Subject: R. E. Ginna Nuclear Power Plant  
Docket No. 50-244  
SEP Topics III-3.A, II-3.A, II-3.B, II-3.B.1  
& II-3.C

Response to NRC Correspondence on SEP Topics  
III-3.A (3/24/81) and II-3.A, II-3.B, II-3.B.1 & II-3.C (4/10/81)

SUBJECT: Trip Report Concerning Stone Revetment at R.E. GINNA Nuclear Generating Plant

R.E. GINNA NUCLEAR GENERATING PLANT  
GEOTECHNICAL APPENDIX

CHECK OF CONTAINMENT CAPABILITY  
TO RESIST EXTERNAL WATER PRESSURE

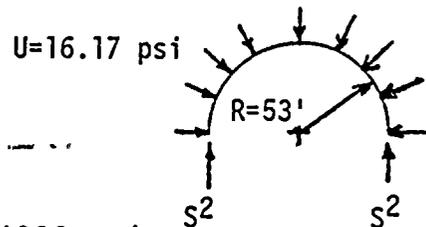
METHOD 1 - ASSUME CONTAINMENT IS A CYLINDRICAL SHELL UNDER UNIFORM RADIAL WATER PRESSURE

h = Water level = 22' high  
 t = Thickness of containment = 36"  
 R = Radius of containment = 53'  
 f<sub>c</sub> = Compression strenght of concrete = 4000 psi  
 p = Max. water pressure  
     = 62.4 X 22 = 1370/144 = 9.51 psi  
 U = Design water pressure = 1.7 X 9.51 = 16.17 psi

1. Determine Membrane Stresses:

$$S_1 = \text{Meridional Stress} = \frac{PR}{2t} = \frac{16.17 \times 53 \times 12}{2 \times 36} = 143 \text{ psi} < 4000 \text{ psi}$$

$$S_2 = \text{Hoop stress (comp.)} = \frac{PR}{t} = \frac{16.17 \times 53 \times 12}{36} = 286 \text{ psi} < 4000 \text{ psi}$$

2. Determine External Collapse Pressure:

$$p' = \frac{t}{R} \frac{S_y}{1 + 4 \frac{S_y}{E_c} \left( \frac{R}{t} \right)^2}$$

$$P' = \frac{36}{53 \times 12} \frac{4000}{1 + 4 \times \frac{4000}{3.6 \times 10^6} \left( \frac{53 \times 12}{36} \right)^2}$$
$$= 94.8 \text{ psi}$$

$$\text{Safety Factor} = \frac{94.8}{16.17} = 5.86$$

TYPICAL SECTION - EAST REVETMENT REACH

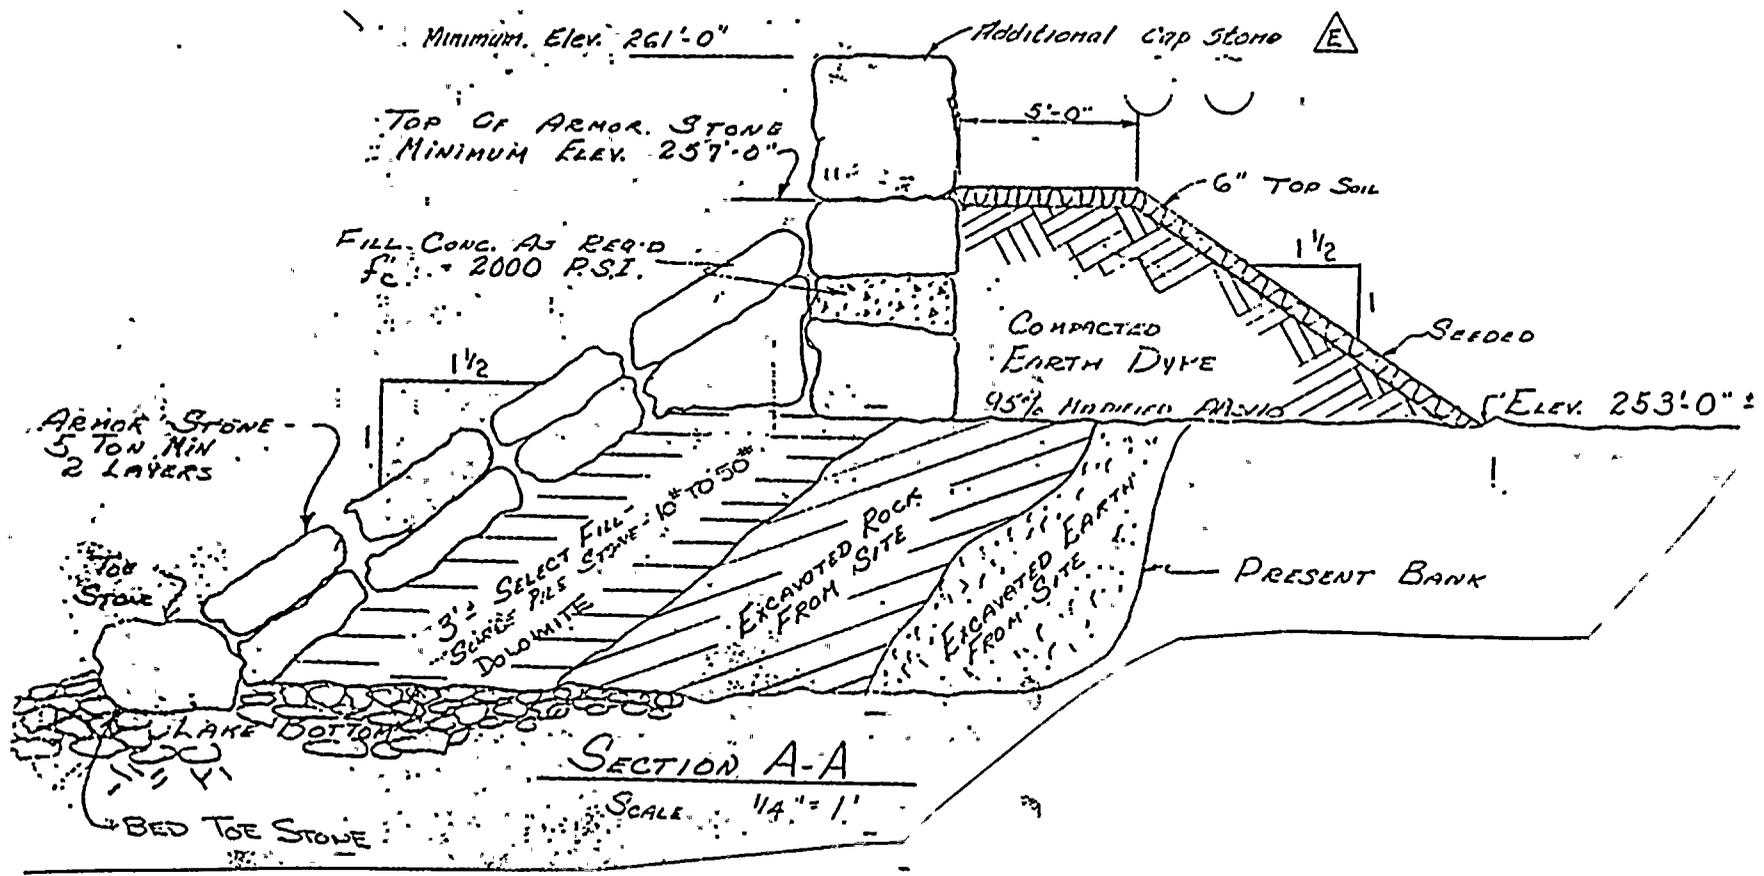
2. The stone revetment was constructed in two reaches; a 420-foot long west reach and a 400-foot long east reach. The east and west stone revetment reaches are separated by the generating plant's discharge canal (see Incl A and B). The revetment was initially constructed with two layers of 5-ton minimum armor stone laid up on a 1-1/2 sideslope to a minimum elevation of 257.0 (msl). Due to high lake levels experienced on Lake Ontario during the early 1970's, the crest elevation of the revetment was raised to a minimum of 261.0 (msl) by placement of a cap stone along the top of the revetment (see Incl C and D for typical cross sections of the revetment).

Photograph 4 - Bluffs adjacent to end of East Revetment (note sloughing), looking west.

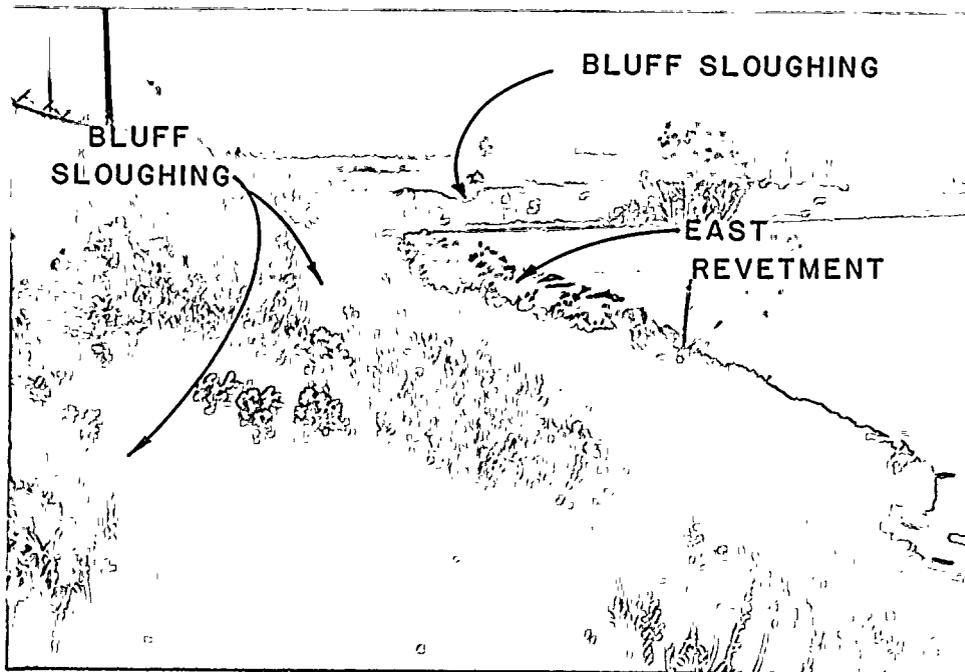
(b) Bluff Stability. Failure scarps in soil are present in the bluffs both updrift and downdrift of the West and East Revetment (Photographs 1, 2 and 4). At the terminus of the West Revetment the scarps are within several feet of the perimeter fence. Recession rates of the bluffs appear to be only slight to moderate.

Photograph 5 - Looking west at crest of West Revetment, near west end.

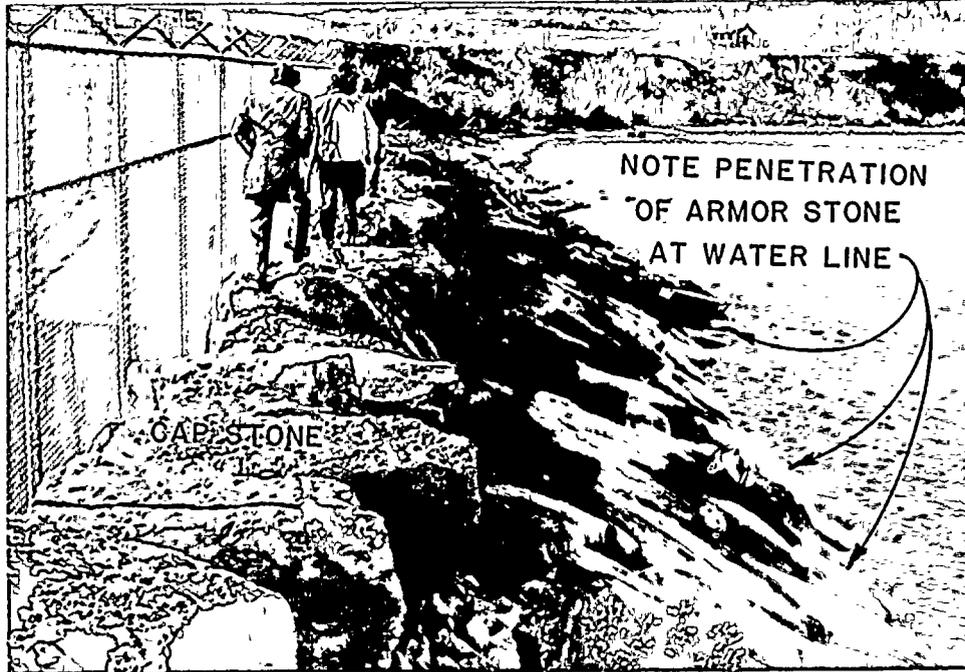
(a) Armor Stone Layers. Over most of the West and East Revetments the armor stone has good rock to rock contact with only a minimum amount of voids (Photographs 5, 6, and 7). The armor face is relatively uniform; the slope has good to excellent penetration at the water line (Photographs 5 and 7). The second layer of armor stone can be seen at numerous inspection points (voids - see Photograph 8). The outer layer of armor stone contains a fairly high amount of cracked stones. Although no counts were made, about one-third or more of the stones contained fractures that penetrate the interior of the stones (Photographs 15 and 16).

Three localized anomalous conditions were present in the armor layer. The first is a layer of fines (4 to 9-inch size) that veneer portions of the upper one-half of the revetments (Photographs 2 and 7). Test pits revealed the presence of a second layer of armor (Photographs 9 and 10). There was no evidence of removal of fines from the interior select fill of the revetment. The upper limit of coarse sand/gravel and drift deposition is below the lower limit of the 4 to 9-inch fines deposition which supports the lack of wave action/run-up that might cause removal of fines from the zone in question (Photograph 2, 3, and 10). Also, the lack of any distress in the cap stone layer tends to rule out removal of fines from wave action (Photographs 5 and 6).

Photograph 7 - East Revetment, looking west, viewing armor stone slope and 4 to 9-inch fines on slope.

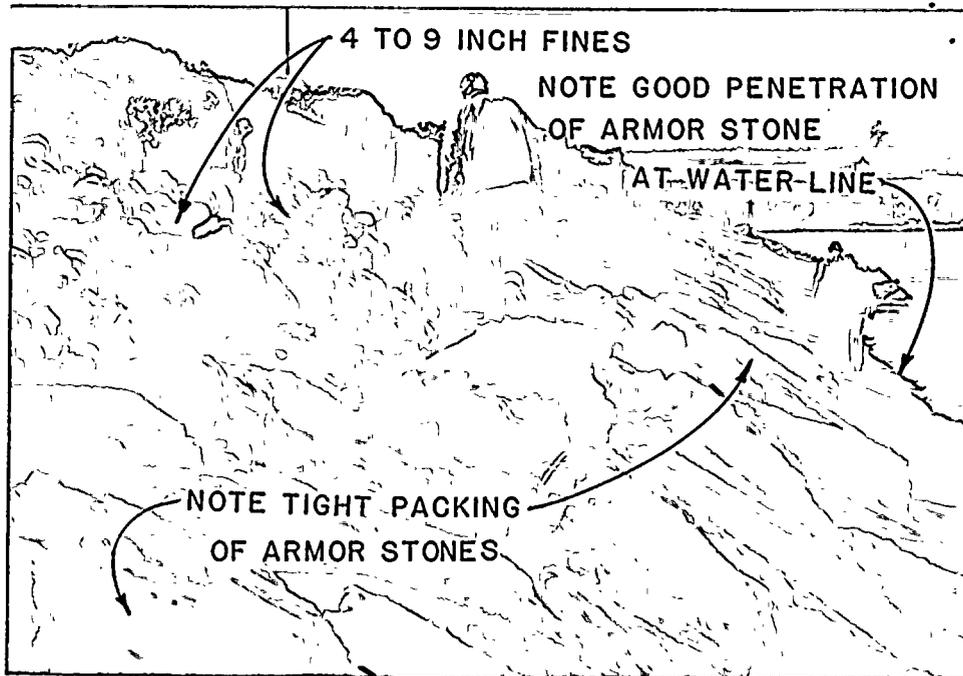
The original revetment construction was completed about 1965, to Elevation 257.0 msl. In 1973, a row of cap stones was placed to increase the elevation to offset the effects of relatively high lake levels (Photograph 6). The armor stone was placed in a "laid-up" configuration, with a side slope of 1 V on 1-1/2 H (Photograph 7).

Photograph 9 - Test Pit in West Revetment revealing continuity of armor stone.

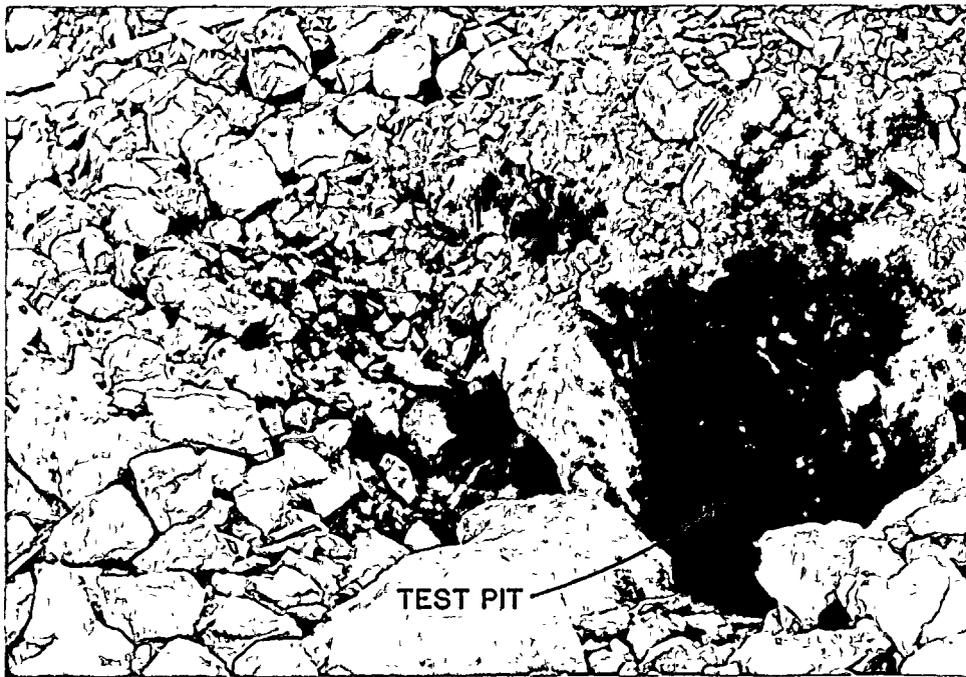
b. Test Pits. Two test pits were excavated near the west end of the West Revetment to verify the presence of armor stone beneath an obscuring layer of 4 to 9-inch stone.

Figure 11 - Localized slippage of armor stones in West Revetment.

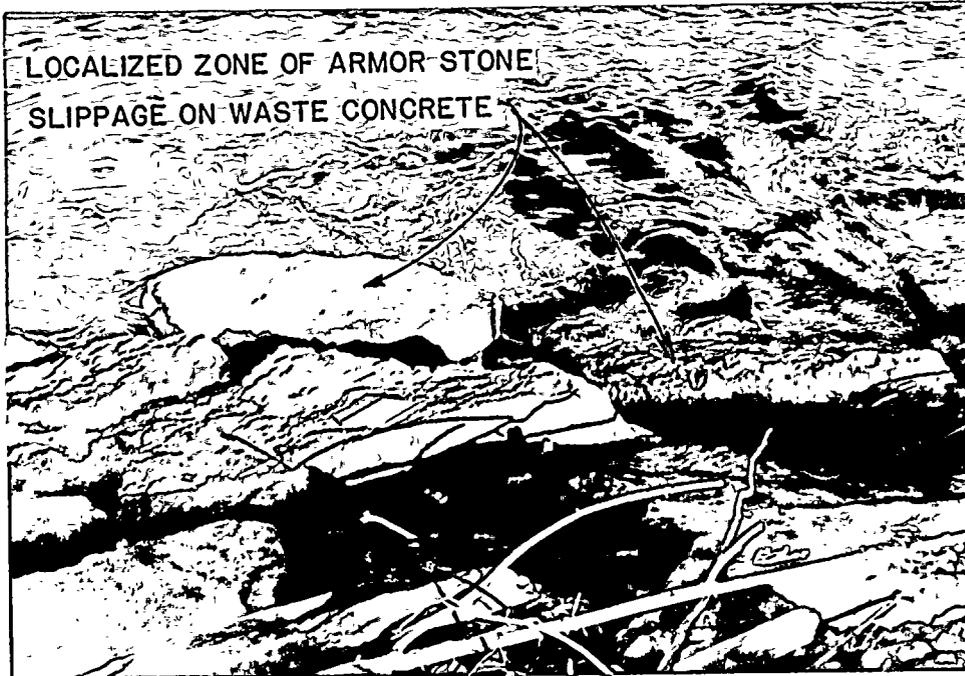
A second anomaly is a localized zone of slippage on the West Revetment. A few armor stones have migrated down the slope on waste concrete placed during construction (Photograph 11). The stones have displaced down the slope several feet in some cases resulting in a minor loss of rock to rock contact.

Photograph 12 - Large linear void in East Revetment beneath cap stones.

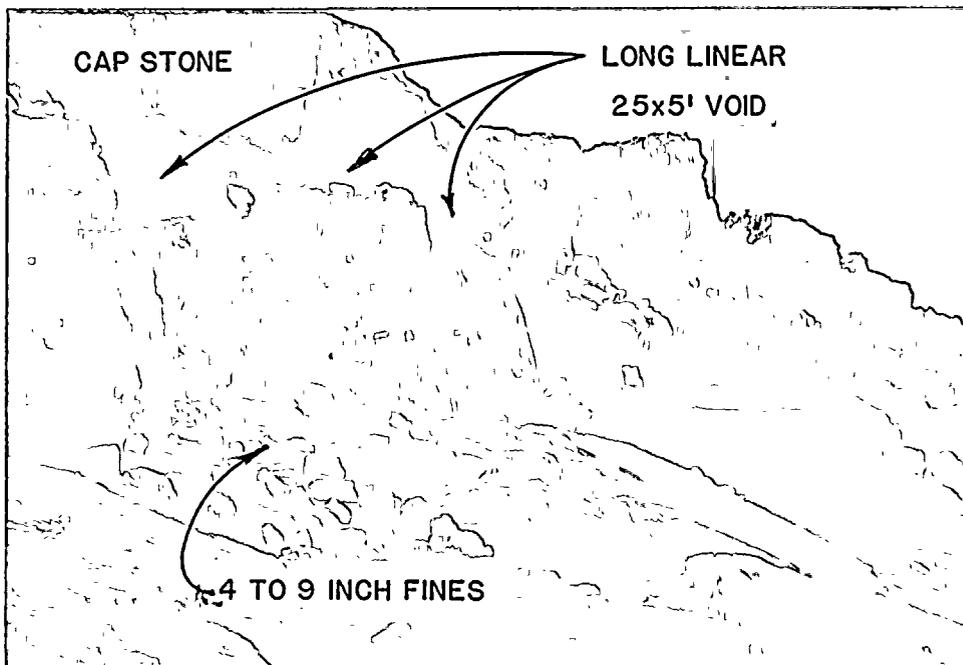
A third anomaly is located on the East Revetment. A rather long linear void (about 25 X 5 feet) is present directly under the cap stones (Photographs 12, 13, and 14). The void is located some 100 feet from the west end of the revetment. The utility stated that the void was a construction oversight; i.e., the void was present at end of construction. This appears to be the case; there was no evidence to indicate removal of fines from the interior of the revetment. Also, there was no distress in the overlying cap stone.

Photograph 17 - Typical fractures in cap stone.

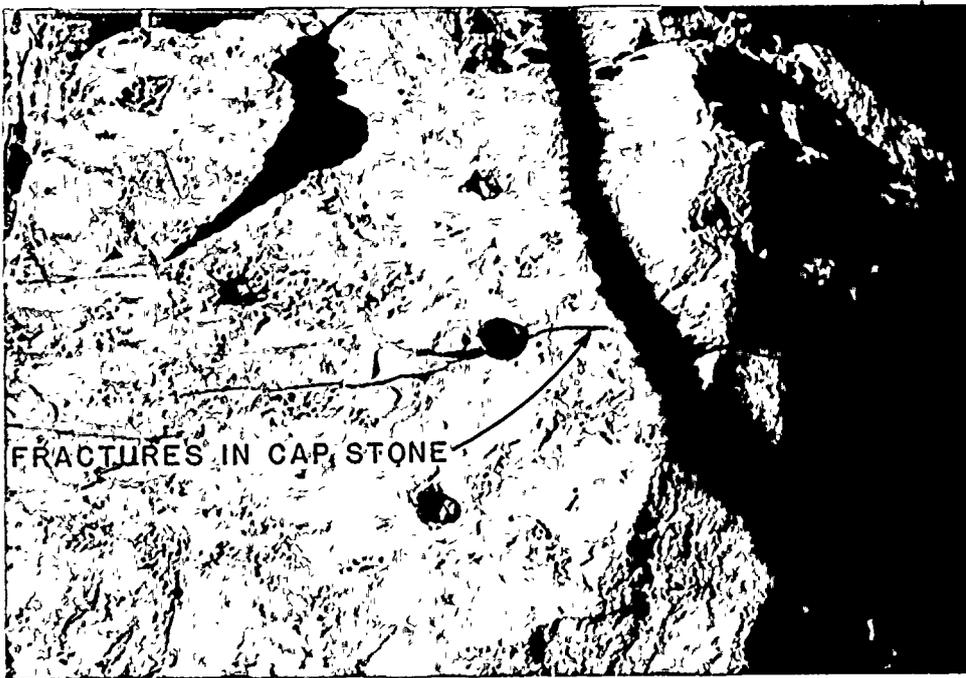
(b) Cap Stone Layer. A row of cap stones were placed at the original revetment crest for added protection. The stones appear fairly uniform in alignment and show no signs of distress that would be indicative of settlement or migration of armor stone down the slope (Photographs 2, 5, 6, and 7). The cap stone layer contains a very high percentage of cracked stones. Although no counts were taken, the vast majority of the stones contained fractures that penetrate the interior of the stones (Photographs 17 and 18).
